**Explanation of Significant Differences for the
Rattlesnake Creek Portion of the Ashland Sites**

Tonawanda, New York

September 20, 2004

SUPPORT AGENCY COMMENTS AND RESPONSES

Figure 3. Rattlesnake Creek

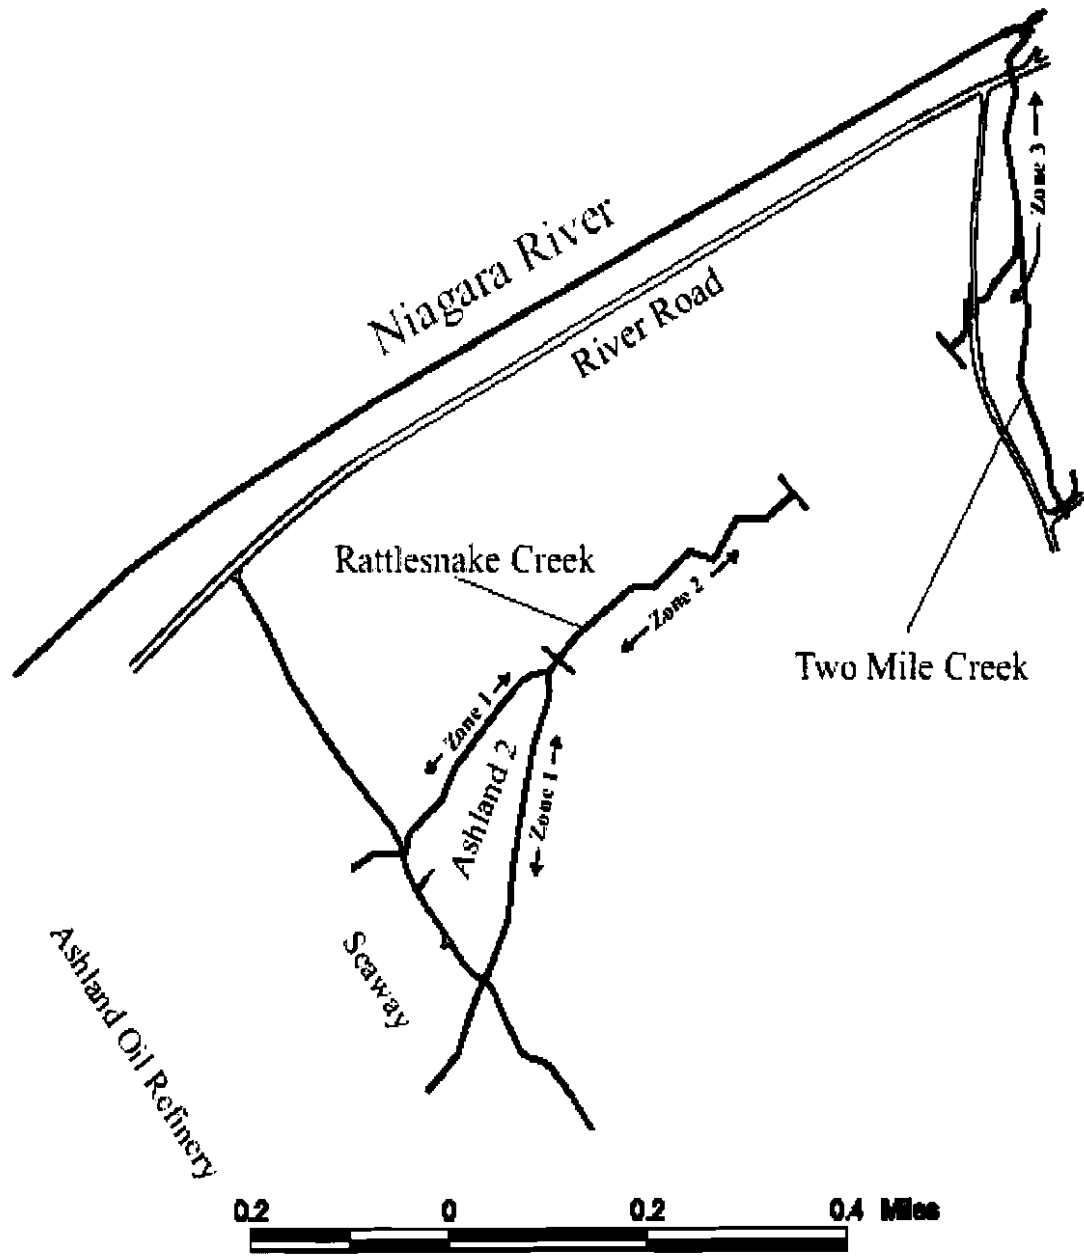
Comment # 1: Page 3, Section III.A., first paragraph, penultimate sentence. Suggest you rephrase the term "...where the creek disappears in the pond area." This implies we don't know where the creek flows. Suggest it be changed to read "...where the creek flows into the pond area and continues underground."
